**Historical Architectural Review Board
COA Preliminary Review Sheet**

HDC-2025-000112

Address: 202 N 8th Street

Proposal: Replace door with historical appropriate wooden door

CURRENT CONDITION OF DOOR

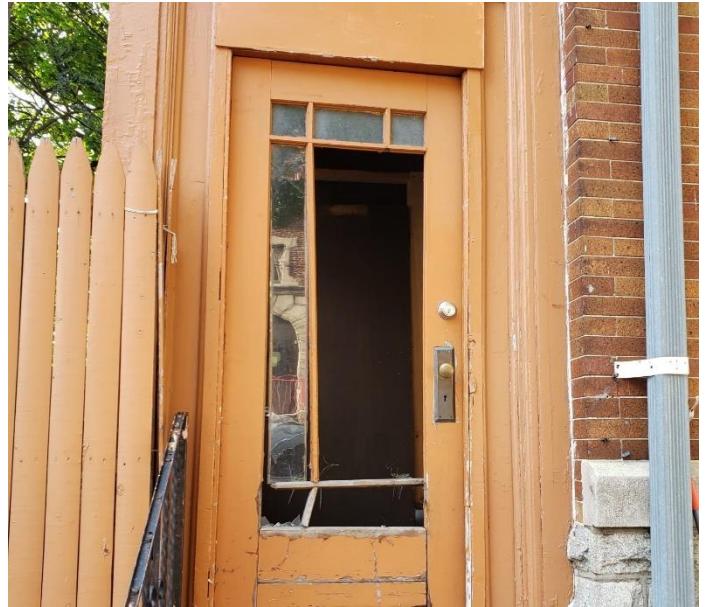
Observations & Comments: Staff observed that a door was installed along Linden Street that is not permitted in the historical district. It appears that the door opening has been altered to accommodate the size of the door that is currently installed

The applicant is seeking to replace a side/rear entry door. The previous door was damaged, and a tenant replaced the door with a non-appropriate style door. The applicant presented a salvaged single lite wood door. Door hardware was not included in the application materials; Mr. Hart noted that door hardware contributes to the historic visual aesthetic of the building.

The HARB discussed the proposed door, and potential appropriate configurations. Google Maps imagery from 2016 indicate that the previous door was not the original; a 6-pane door was in place at that time. The previous door, and the 2016 door were both complementary styles to the building.

- The replacement door is of historic material, meeting historic dimensions, sized to the original dimensions
- That the lite dimension is 4, 6, 9, or 15 lites
- The hardware is in keeping with historic guidelines
- All modifications approved by staff prior to installation
